Application: DR 21-04-State Street Multi-Family

## Comments for the Planning Commission Meeting for DR 21-04 State Street

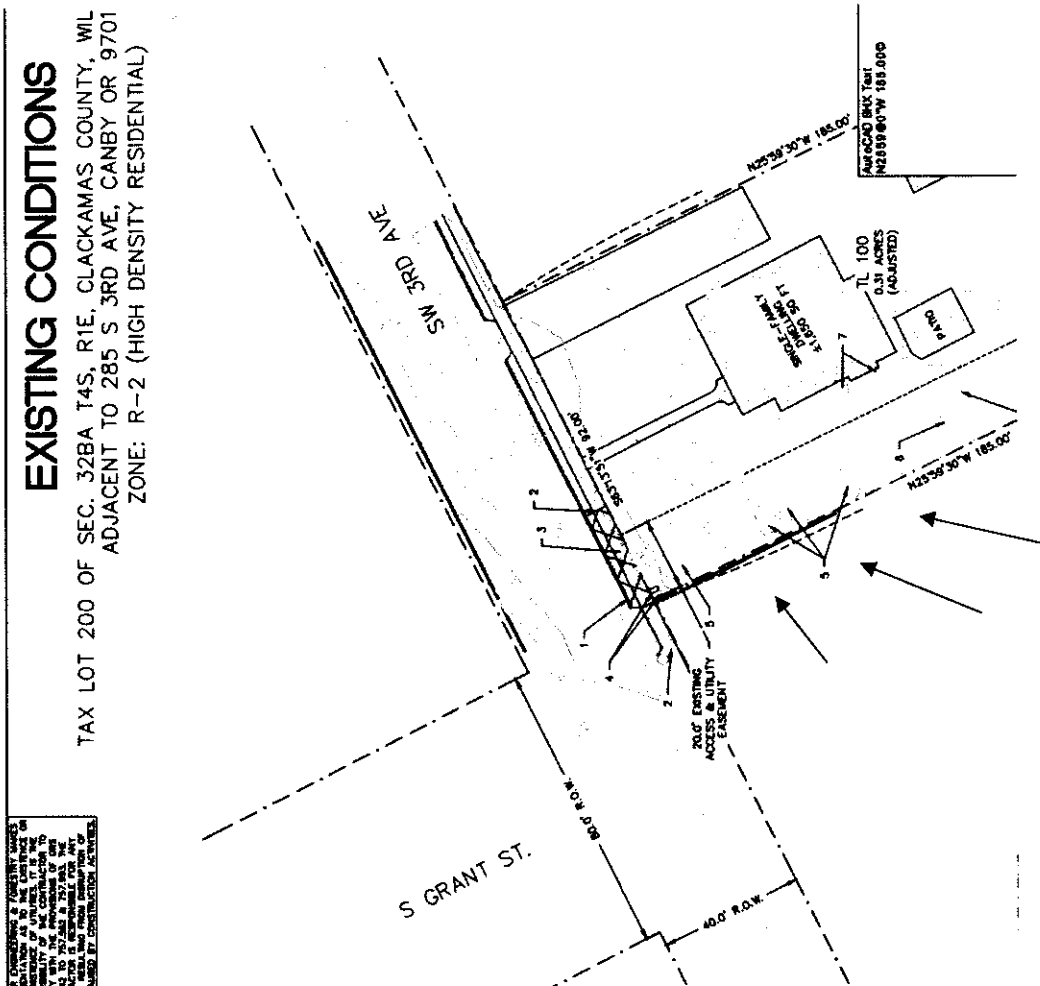
EXPLANATION: The driveway spacing for this new development fails to comply with the spacing to TWO local streets: SW 3<sup>rd</sup> Ave AND also with Grant Avenue. In addition, it is located within about 10 feet of the driveway to the neighbor to the west. A Traffic Impact Report will provide insight into how to mitigate this issue, including possibly imposing a

The engineer's drawing of the proposed location of the new driveway is seen in the diagram below. The engineer did not include the existing driveway for the neighbor to the West, however, it runs parallel to the subject property, in the area indicated by my arrows.

Illustration of cars meeting head-on in the one-way lane while another car queues for entry; will the green car back out onto SW 3<sup>rd</sup> Ave?

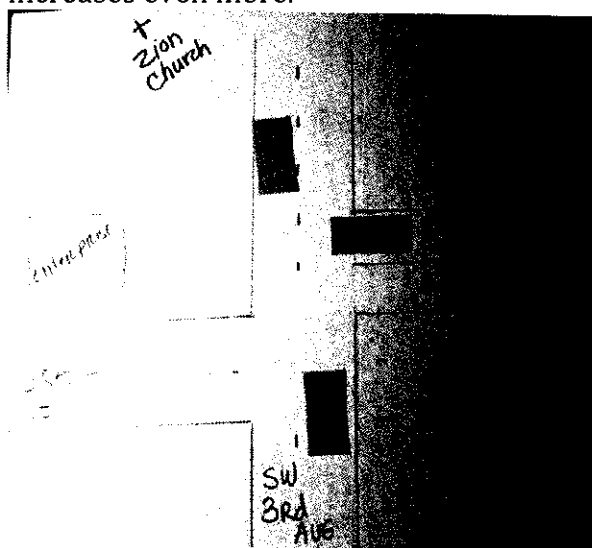
- 1) How many **drive lanes** are going to be provided into the development? Will there be one lane for cars coming in, and a second lane for cars exiting? Or do the residents actually all have to share a single lane? This is significant, because it can cause an impact at the entrance on SW 3<sup>rd</sup> Avenue, if several cars are waiting in a queue to gain access to their dwellings in the apartment complex. This can GREATLY impact the flow of traffic on SW 3<sup>rd</sup> and SW Grant Street.

Imagine CAR #A arriving at the entrance drive at SW 3<sup>rd</sup>, beginning to turn in, and suddenly realize that CAR #B has already driven half way down the lane to exit; CAR #A would have to back out onto SW 3<sup>rd</sup> Avenue (if there weren't other cars already in queue also). There could be cars on SW Grant also waiting in queue to enter the development, causing extreme chaos and danger. Add pedestrians to the narrow drive, and the chaos increases even more.

Illustration of the parallel driveways, and a car exiting from each simultaneously.

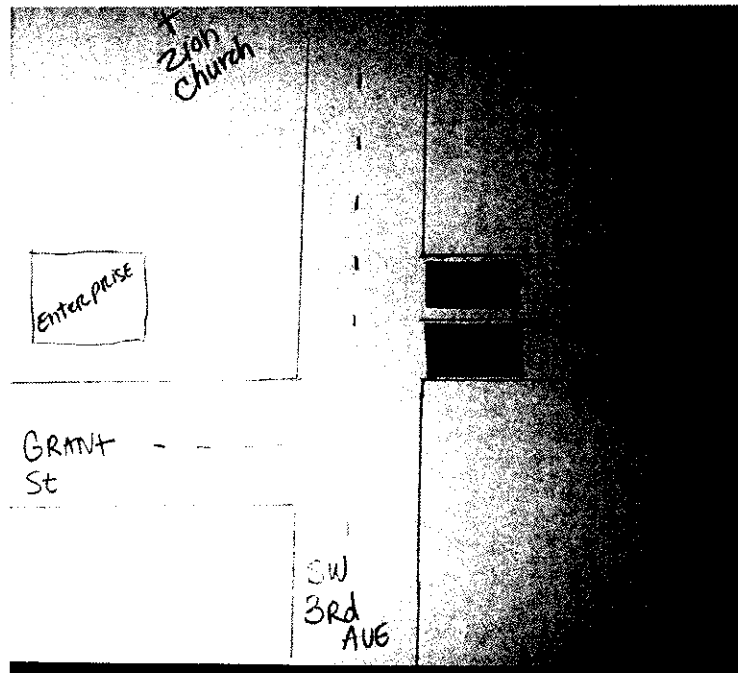
A second issue is the proximity of the proposed access drive to the driveway of the neighbor to the west; there will be a great deal of confusion when cars from both driveways attempt to exit side-by-side, onto Grant Street, simultaneously! Especially if the car on the left needs to turn right, and vice versa.

A Traffic Impact Study will help find any solutions for the above issues and others.

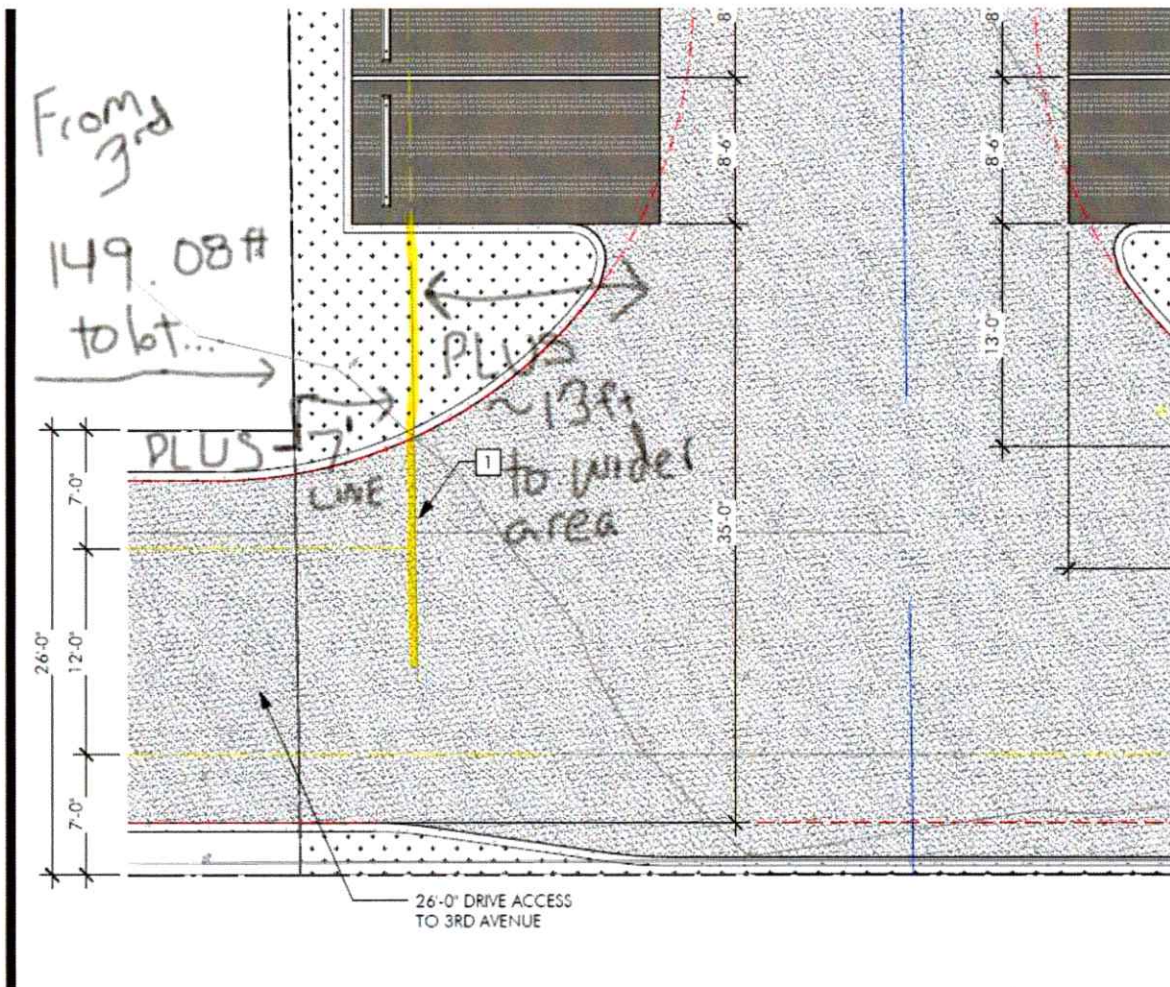
This flag lot is non-conforming. Access to the lot can only be reached via the approximately 170' deep, 26' wide easement. Though there are conflicts in the documentation (185' deep before the lot line adjustment) it is still roughly 170' deep after the adjustment and taking the developer's engineering spec into account, as approximately 20 ft of the back lot remains width restricted before opening up for the turnaround (forgive the markup). The paved parking spaces are 18 ft deep:

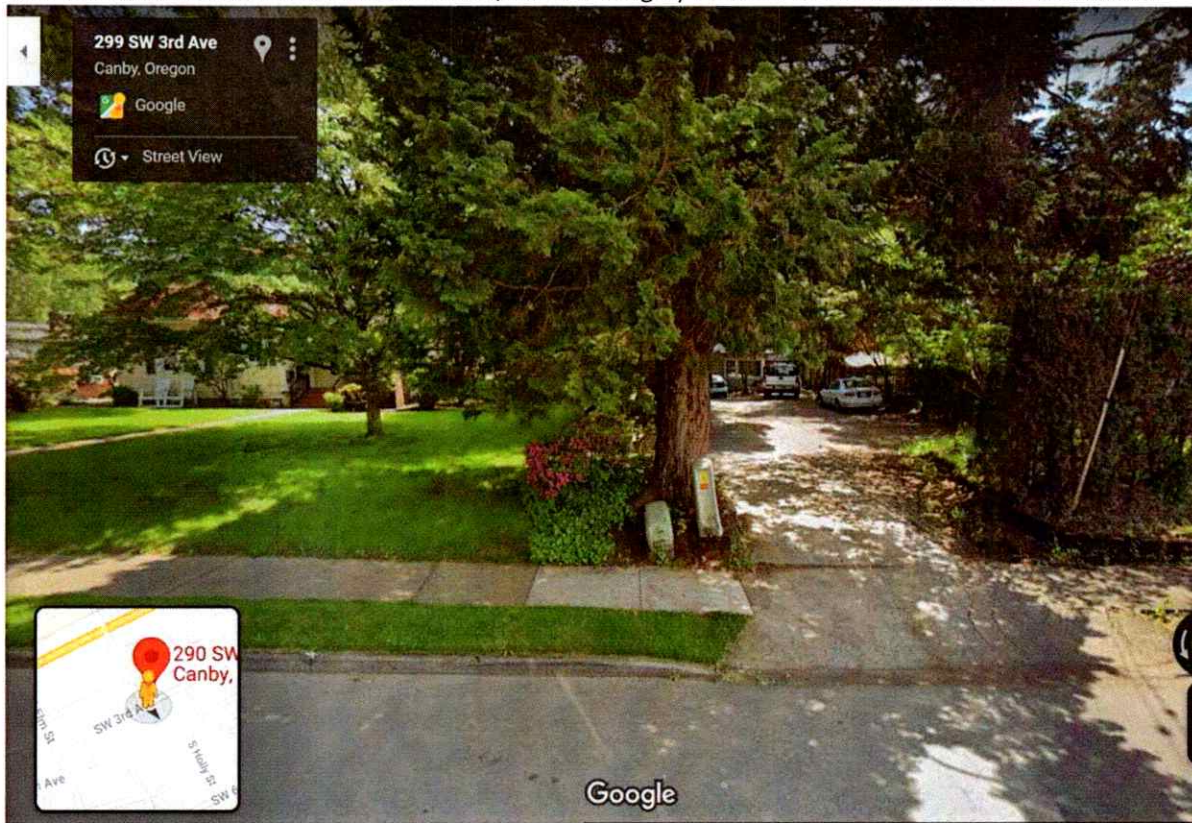
The distance of the easement to the intersection of Grant/SW 3<sup>rd</sup> is less than the 50 ft required for driveways on Neighborhood Routes. The neighboring driveway at 299 SW 3<sup>rd</sup> is less than 10 ft from the easement as well – it's 0 ft! While exceptions can be made for non-conforming lots, they still need a critical review to ensure safety.

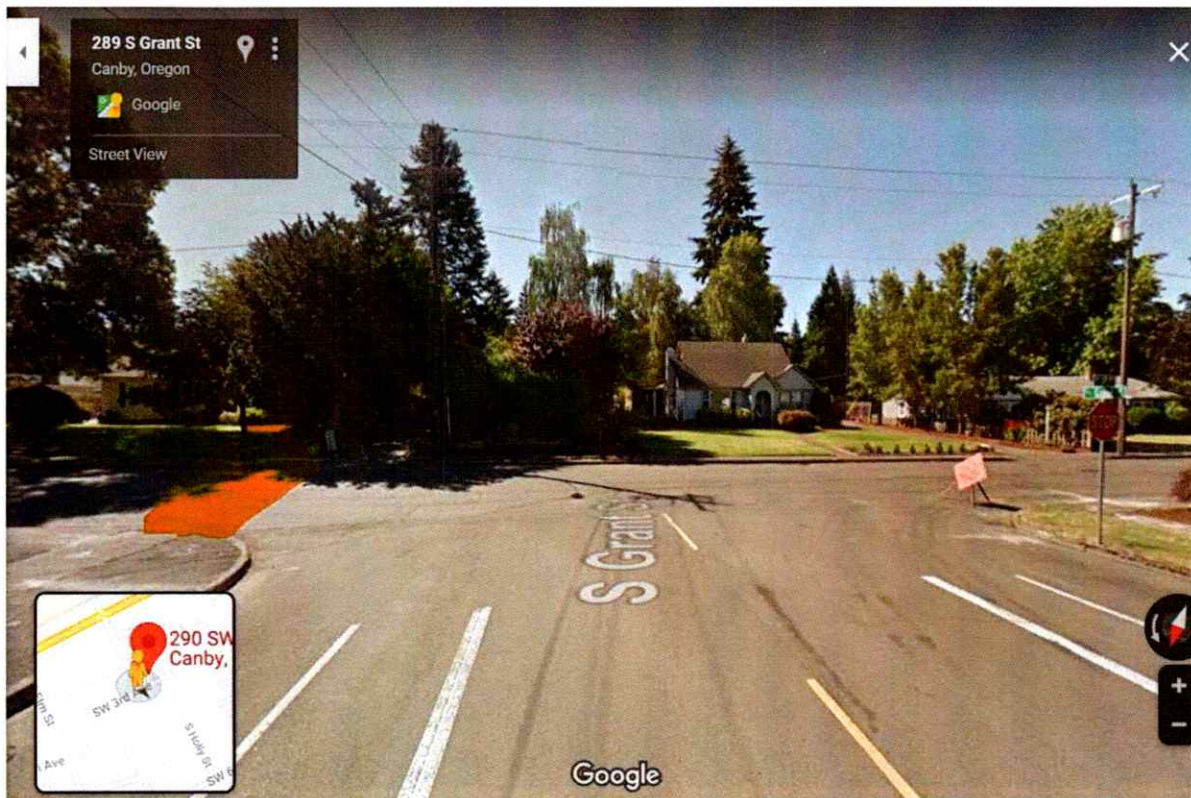
The view on SW 3<sup>rd</sup>, headed West, approaching Grant. The easement will be added before the existing driveway seen on the left.

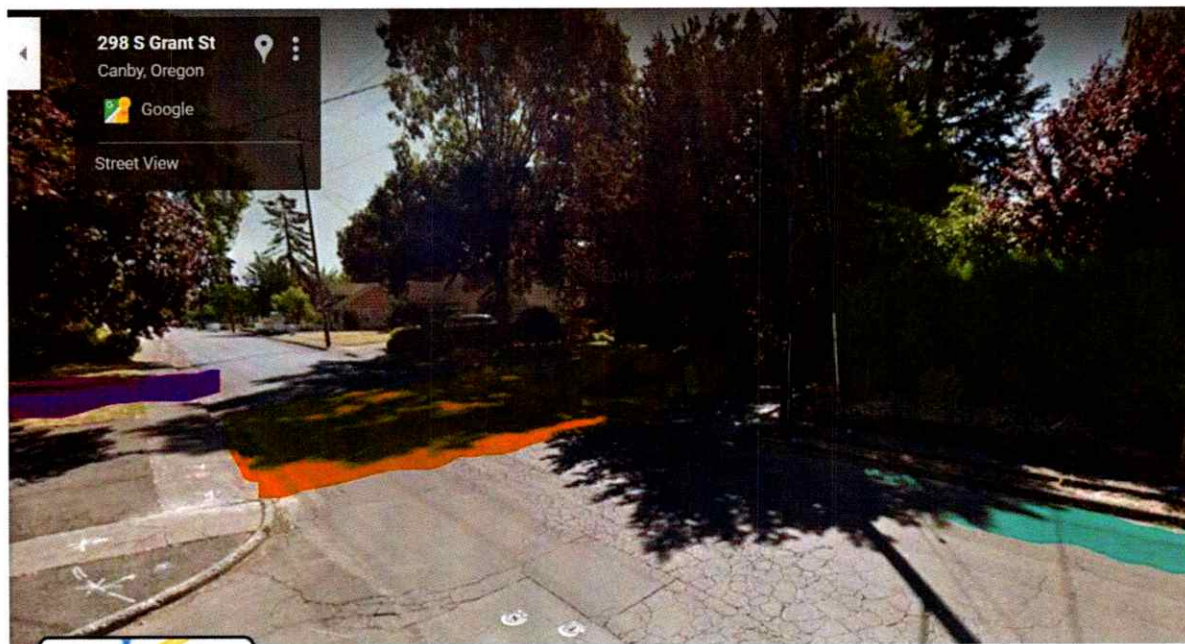
Another view of the intersection and distance vehicles leaving the easement will be crossing, in order to turn on to Grant or join Westbound traffic on SW 3<sup>rd</sup>. Driveway for 290 SW 3<sup>rd</sup> in purple. Vehicles can park between 290 SW 3<sup>rd</sup> and the corner on the North side of the street (directly across from easement), and also park in front of 299 on the South side of SW 3<sup>rd</sup> (area in blue):

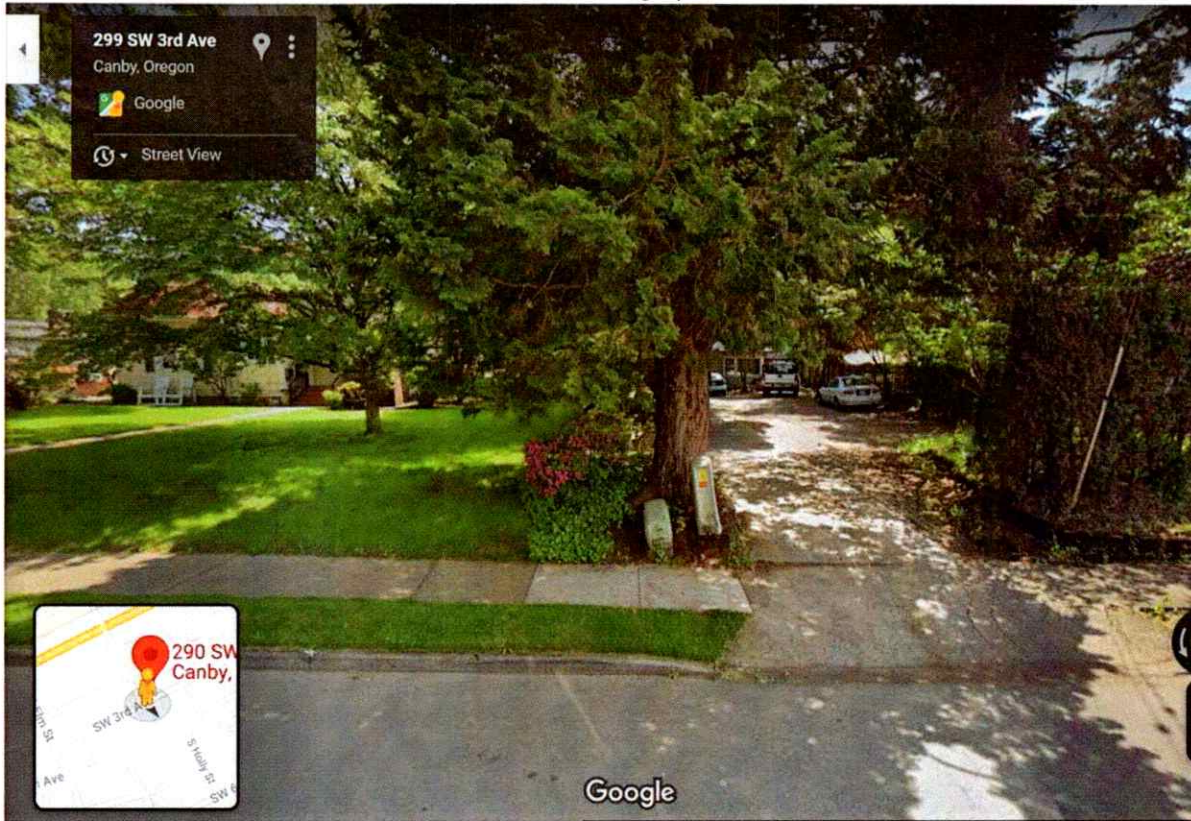
The distance of the easement to the intersection of Grant/SW 3<sup>rd</sup> is less than the 50 ft required for driveways on Neighborhood Routes. The neighboring driveway at 299 SW 3<sup>rd</sup> is less than 10 ft from the easement as well – it's 0 ft! While exceptions can be made for non-conforming lots, they still need a critical review to ensure safety.

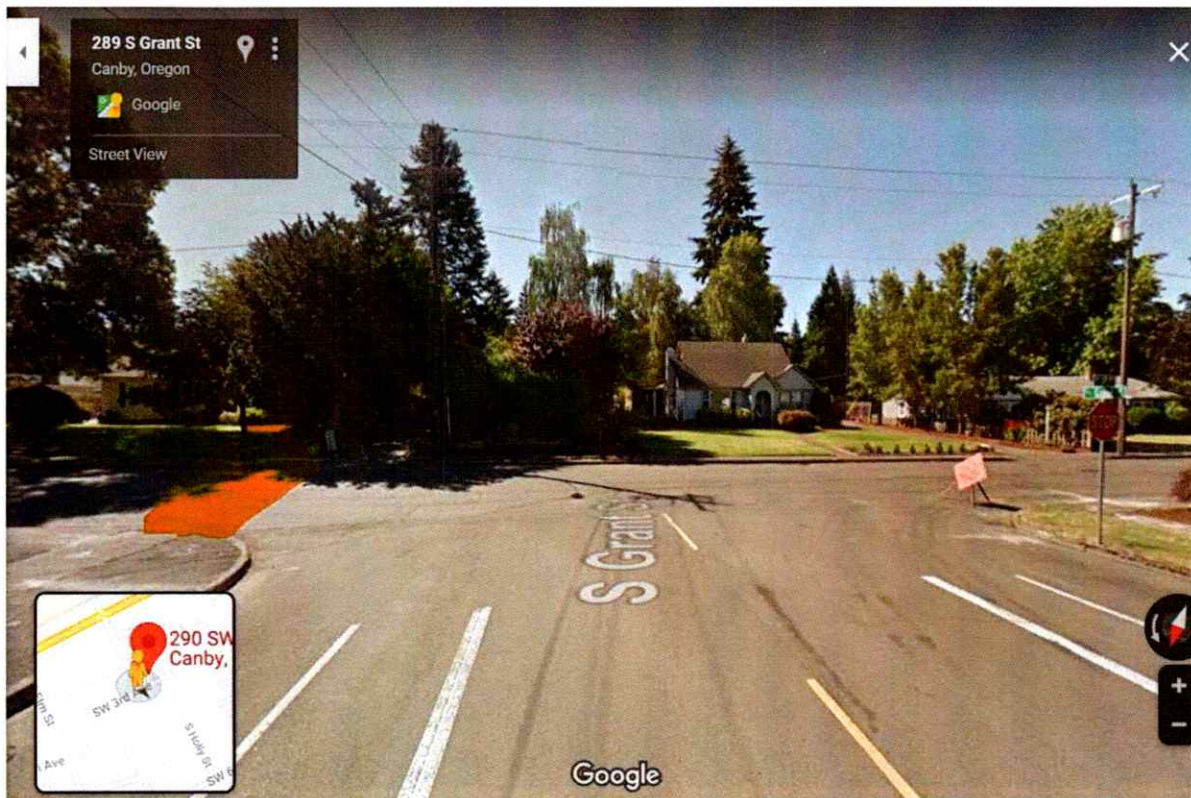
The view on SW 3<sup>rd</sup>, headed West, approaching Grant. The easement will be added before the existing driveway seen on the left.

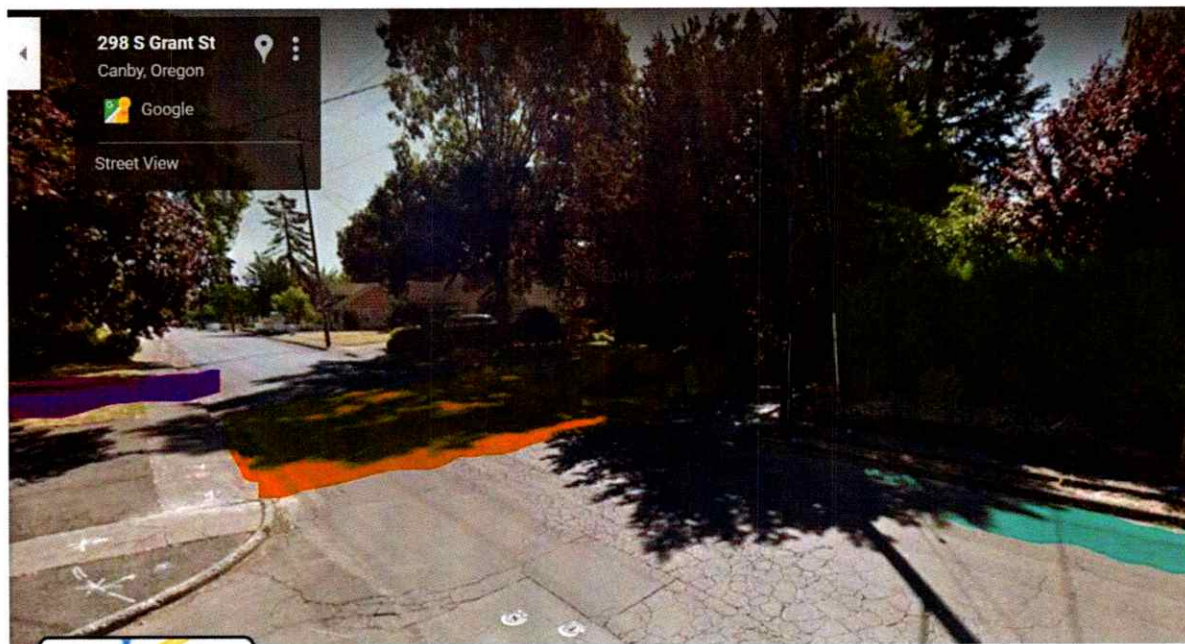
Another view of the intersection and distance vehicles leaving the easement will be crossing, in order to turn on to Grant or join Westbound traffic on SW 3<sup>rd</sup>. Driveway for 290 SW 3<sup>rd</sup> in purple. Vehicles can park between 290 SW 3<sup>rd</sup> and the corner on the North side of the street (directly across from easement), and also park in front of 299 on the South side of SW 3<sup>rd</sup> (area in blue):
